<b>ITEM NUMBER</b>	13.3
<b>SUBJECT</b>	Concept design for Duck River Nature Trail Stage 1, Silverwater Park
<b>REFERENCE</b>	F2024/00282 - D09519216
<b>REPORT OF</b>	Senior Project Officer Transport Planning

To approve the concept design for Duck River Nature Trail Stage 1 – Silverwater Park.

**Figure 3: Proposed Final Concept Plan for endorsement**

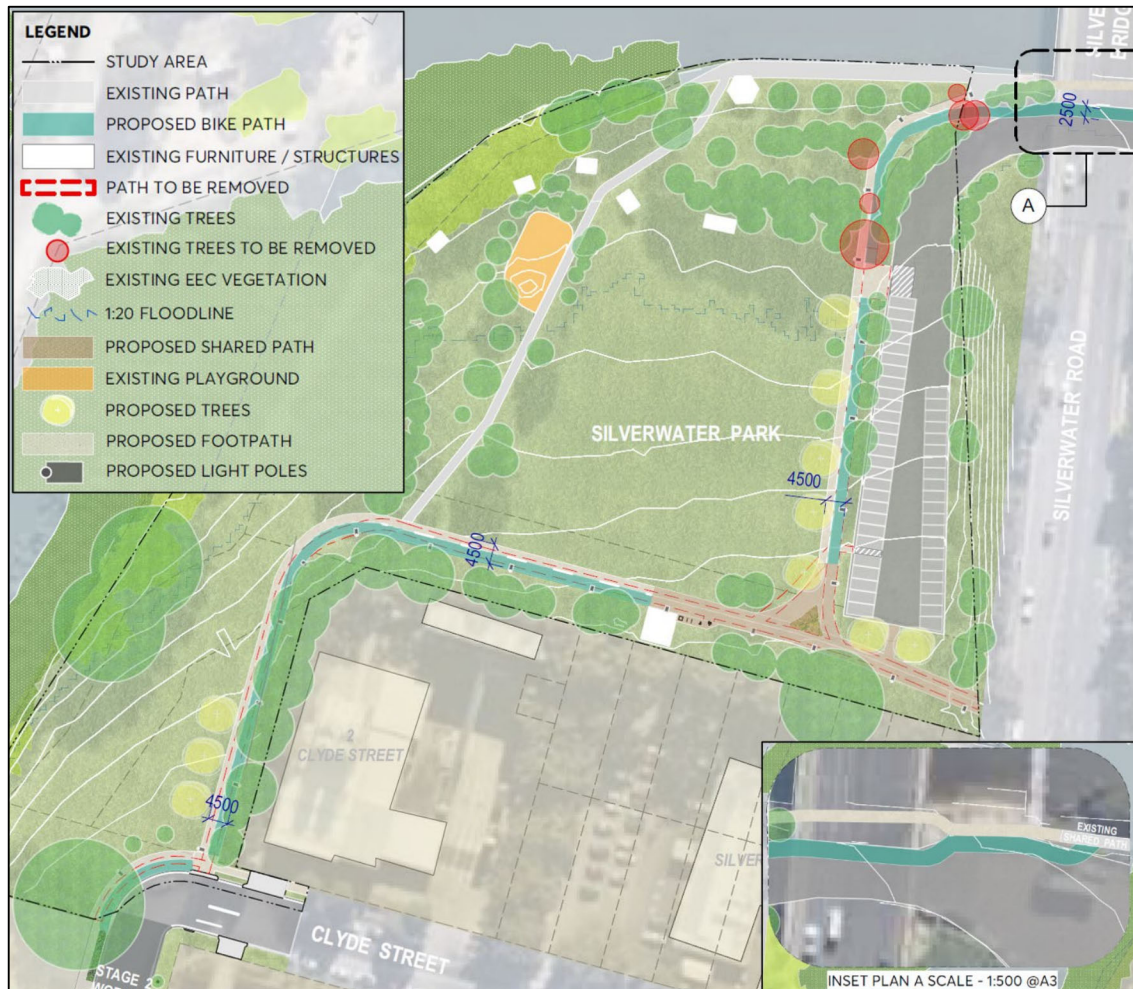
Feedback Theme	Stage 1 Project Response
a) Careful management of open space and ecological areas is needed to minimise impacts	In Silverwater Park the path has been located at the outer edges of the park on a similar alignment to the old path to minimise impacts to the open space and existing vegetation. A total of 6 trees are to be removed and have not been identified to be of high value. However, a total of 10 new offset trees will be planted.

c) Safety of the path, particularly for pedestrians and conflict with cyclists	The path proposed in Silverwater Park will be 4.5m wide for most of its length, with separate areas demarcated for pedestrians and cyclists for a majority of its length.

Date	Stakeholder	Stakeholder Comment	Council Officer Response	Responsibility
1/7/2024	SOPA	Ensure there is a smooth transition from the shared path to the footpath and the bike path under the bridge.  Support for the improved paths at the boat ramp.	This feedback will be incorporated into the design.  Support noted.	Group Manager Infrastructure Planning and Design

18. As a result of feedback, the following has been incorporated in the recommended concept plan for approval (provided in **Figure 3** below and at **Attachment 2**):
- A further 3 new trees have been incorporated on the western side of the path closest to Clyde Street (to the extent possible due to in-ground utilities). This is in addition to the 7 new trees proposed in the draft design.

- b. A new path connection from the southern end of the carpark to the Silverwater Bridge path.
- c. Whilst there will be exclusive paths, protection and priority for pedestrians and cyclists crossing the boat ramp, additional advisory signage and line marking at the boat ramp will be developed to ensure all users take care, give way to one another when necessary and walk, ride and drive to the conditions.
